Record of Decision
Morse Industrial Corporation Site
Operable Unit No. 3
State Superfund Project
City of Ithaca, Tompkins County, New York
Site Number 755010

October 2010

Responsiveness Summary

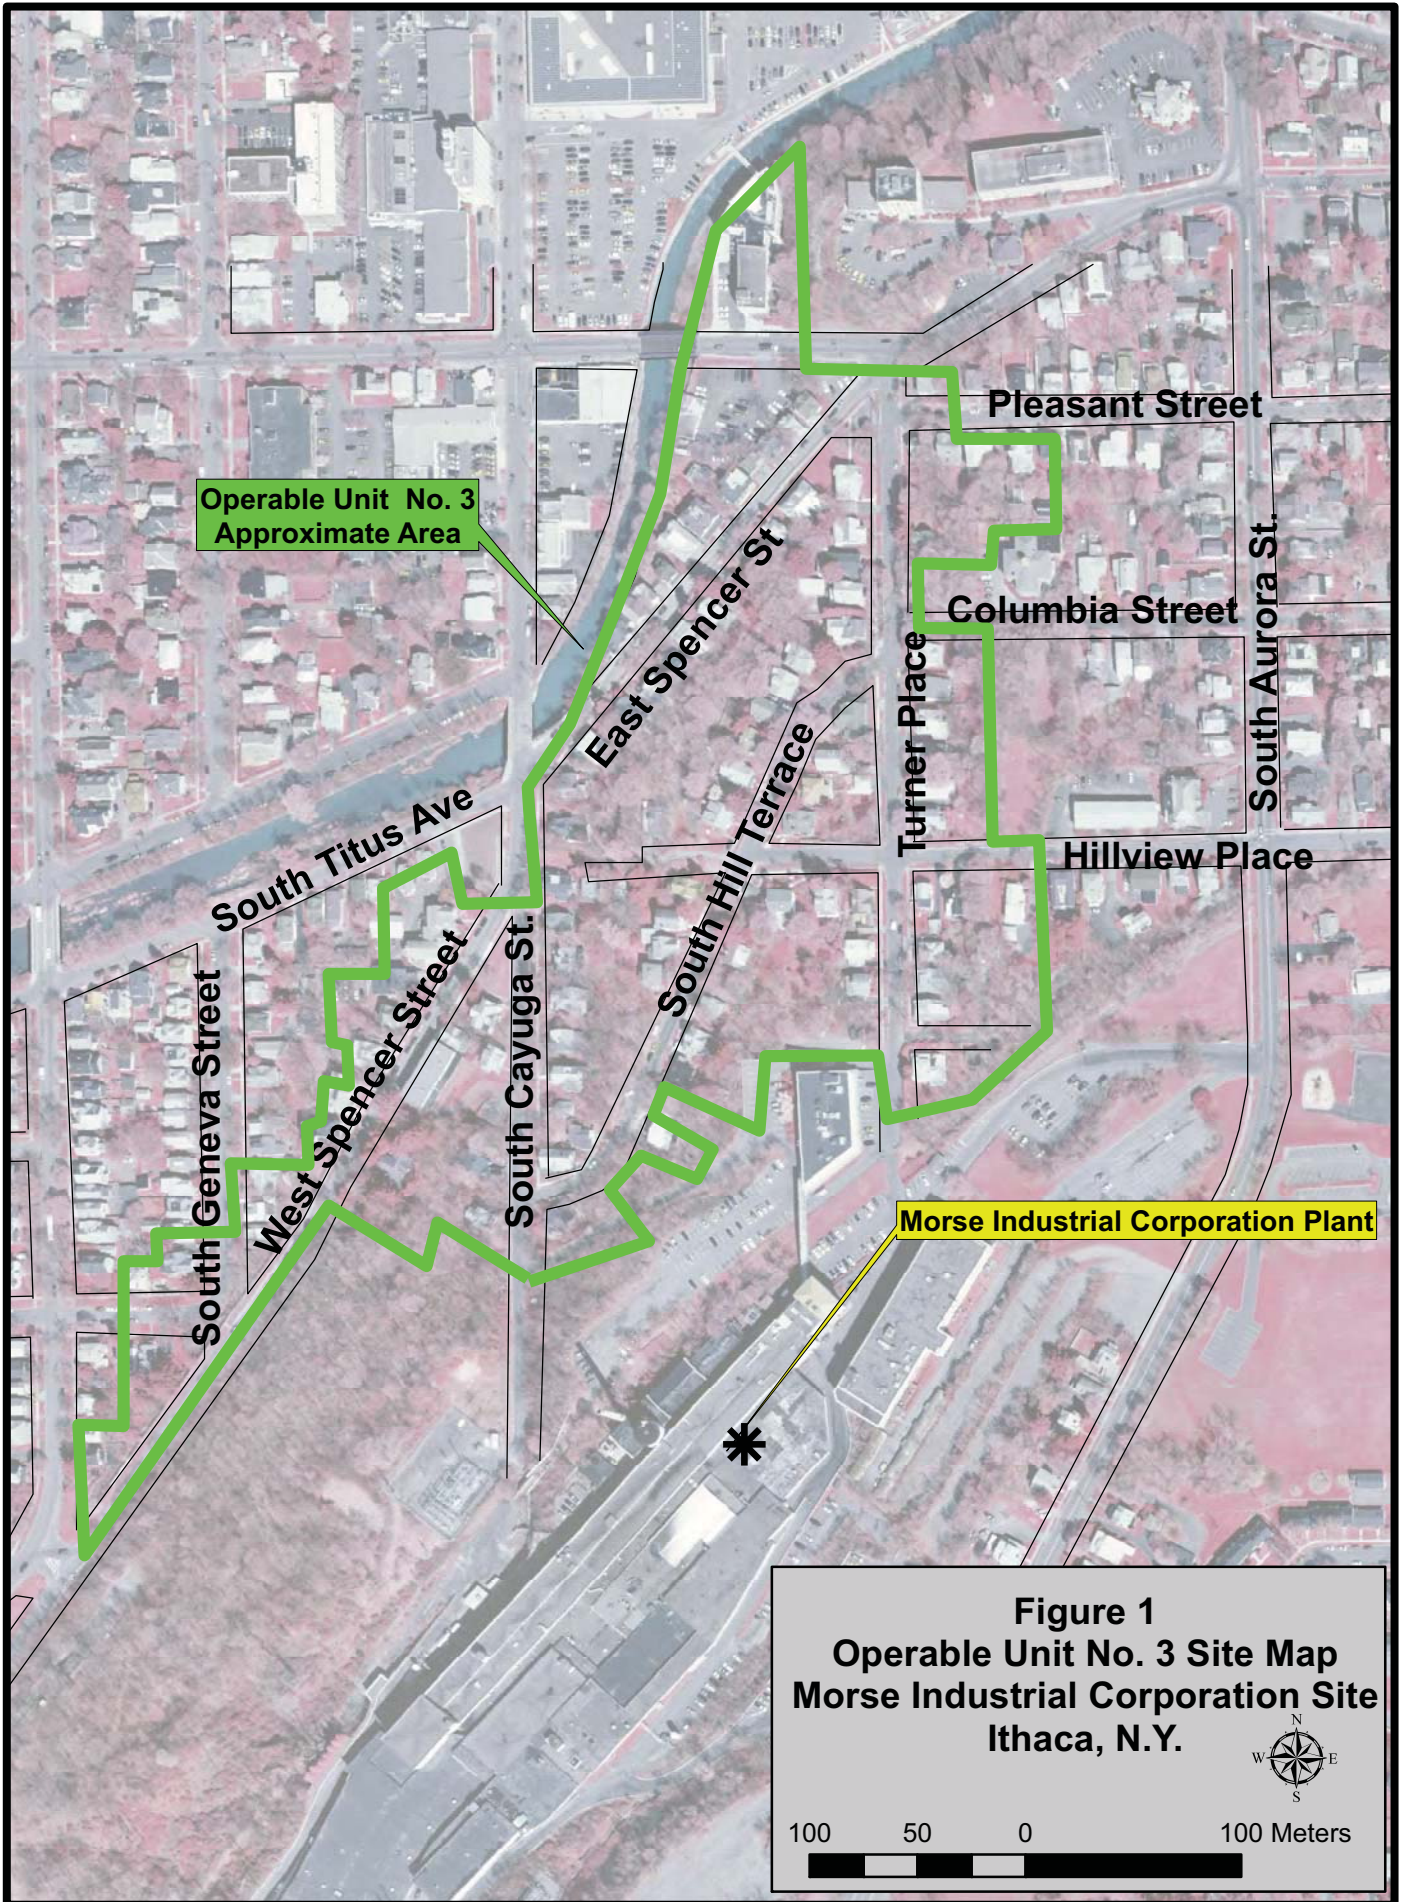
In paragraph one, line one, the site is defined as follows: “The Morse Industrial Corporation site occupies 100 acres along the west side of South aurora Street/Danby Road (Route 96B) in the South Hill portion of the city of Ithaca, Tompkins County, New York (Figure 1).” Figure 1, on Page 15, is titled “Site Map” and includes two delineations, one labeled “Plant Site” and one labeled “OU NO. 3 Approximate Area.” The figure is inaccurate as it does not show the entire Plant Site, the Plant Site boundary line is approximate, and the figure includes OU No. 3 (later defined in paragraph two). The figure and title should be revised and labeled appropriately. In addition, the delineation of the Plant Site on Figure 5 should also be revised and labeled appropriately.

RESPONSE 9: The titles of both Figures 1 and 5 have been revised, and the yellow line has been removed. The intent of Figure 1 is to show the “plant site” in relation to OU No. 3, therefore the entire “plant site” is not shown.

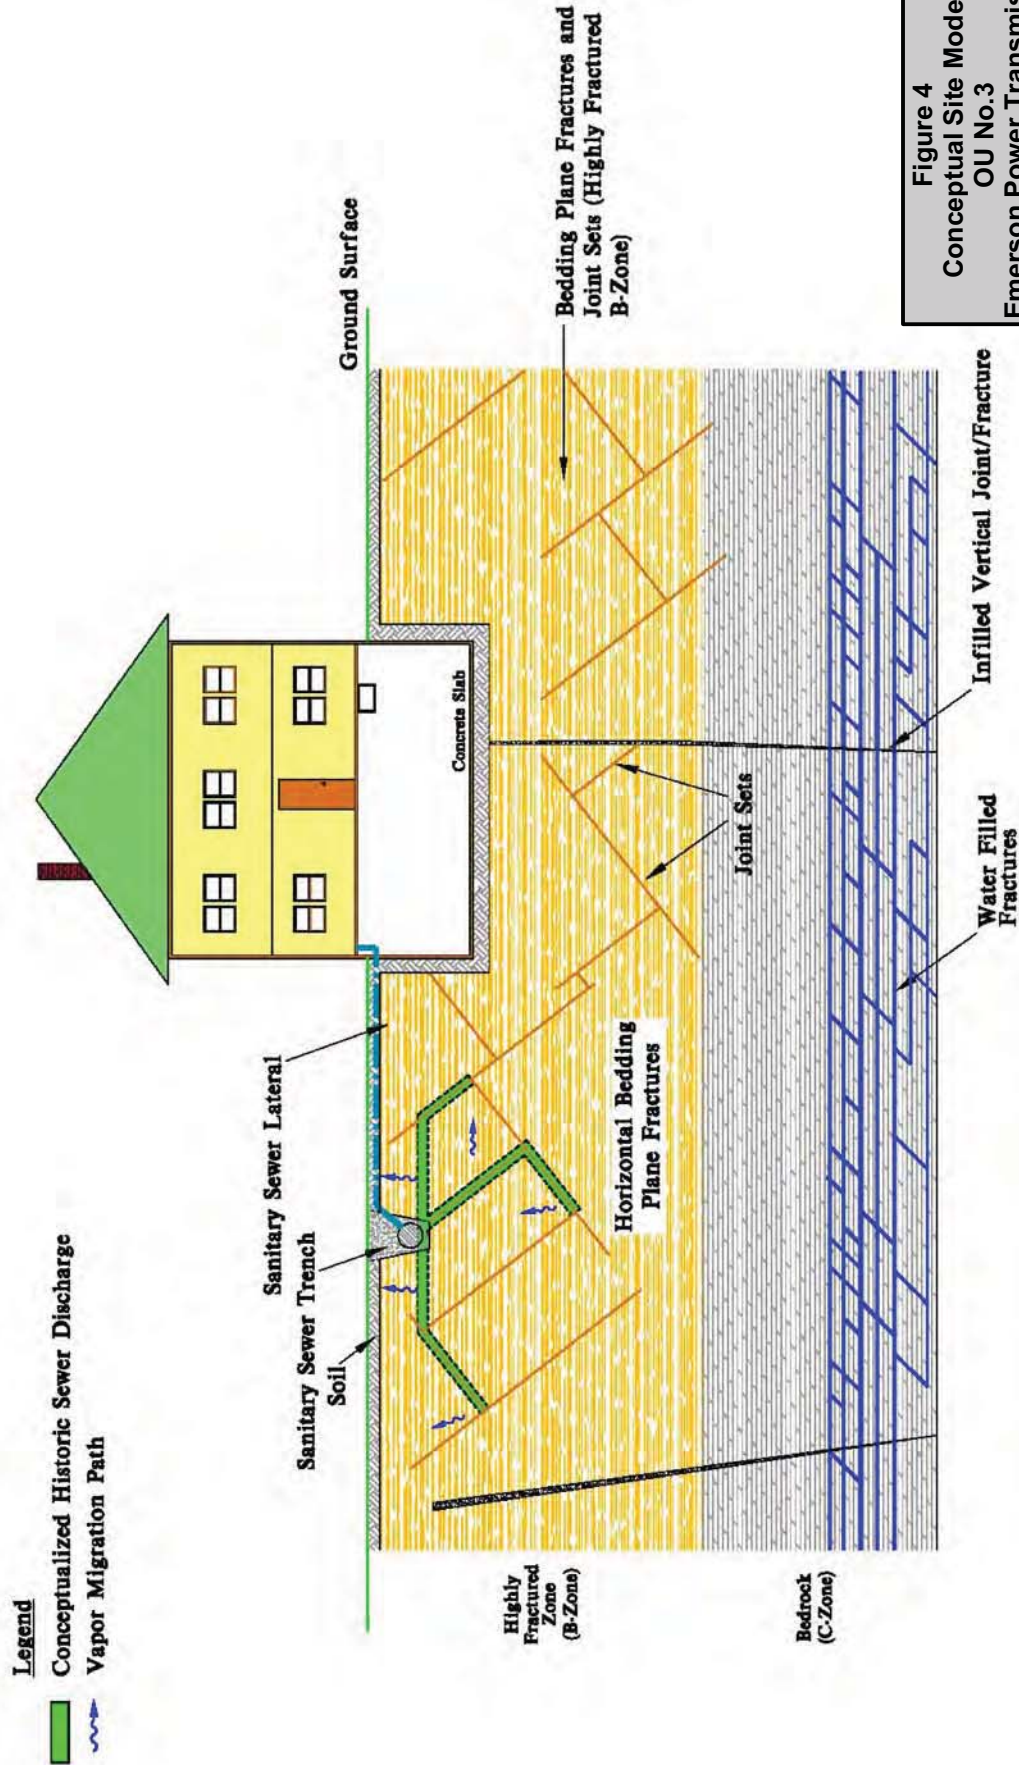
Paragraph five, line one, under subheading “Soil Vapor Intrusion,” references Figure 4 which shows the conceptualized historic sewer discharge to the subsurface. As line one is discussing the five phases of indoor air sampling conducted between the fall of 2004 and winter of 2006/2007, it would be more accurate to reference Figure 3 which delineates the five sampling phases.

Paragraph 5: The text has been modified accordingly.

Figure 4
 Conceptual Site Model
 OU No.3
 Emerson Power Transmission
 Ithaca, N.Y.

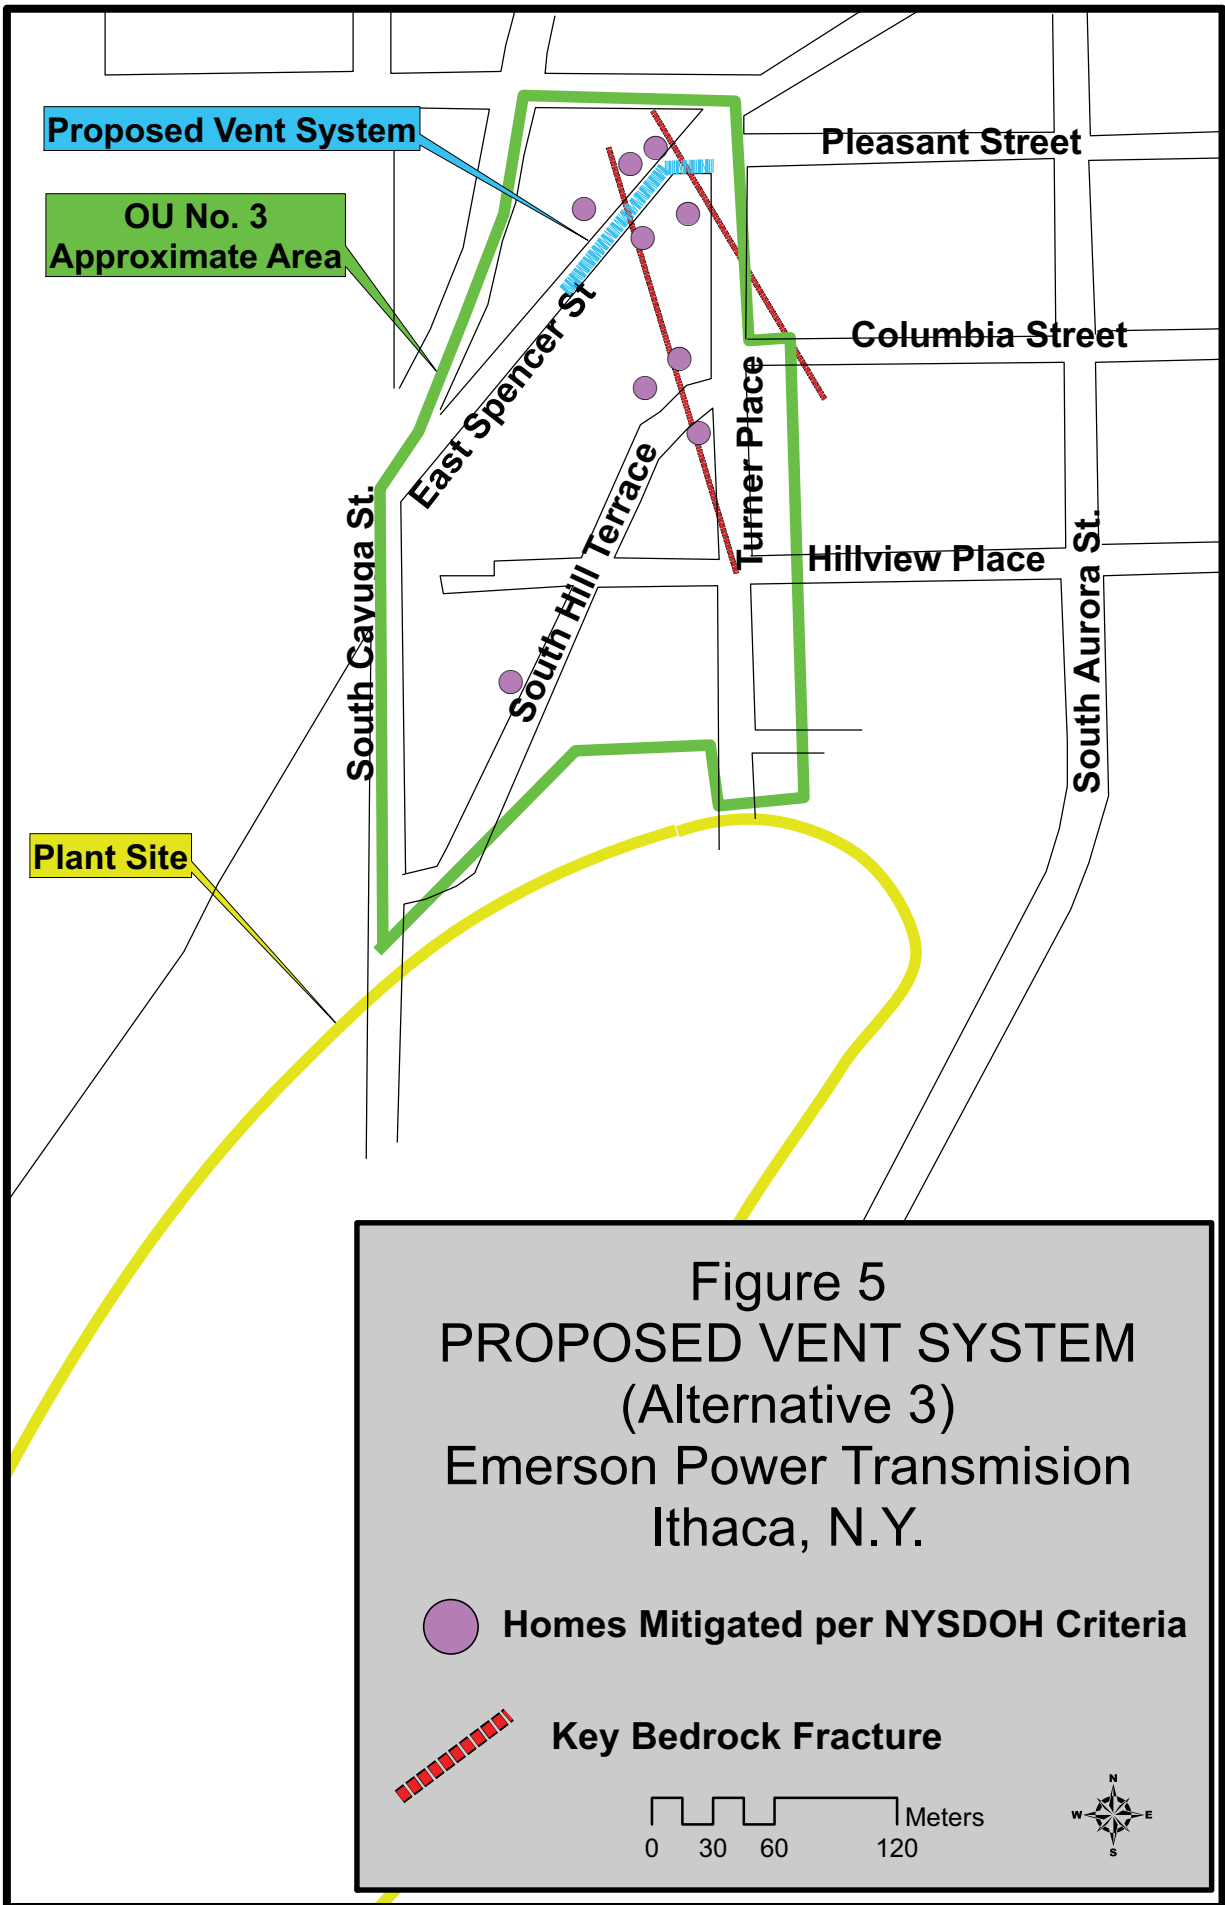
Paragraph one, line one, refers to discharges to the “municipal sewer system”, whereas, Section 2.2 previously referred to discharges to the “sanitary sewer system.” To be consistent, Section 5.1.2 should be revised to indicate “sanitary sewer system.” Line 12 in the same paragraph discusses the conceptual model for vapor transport in the subsurface and references Figure 3 (vapor intrusion investigation phases). Figure 4 should be referenced as it illustrates the conceptual site model.

Paragraph 1: The text has been modified accordingly.
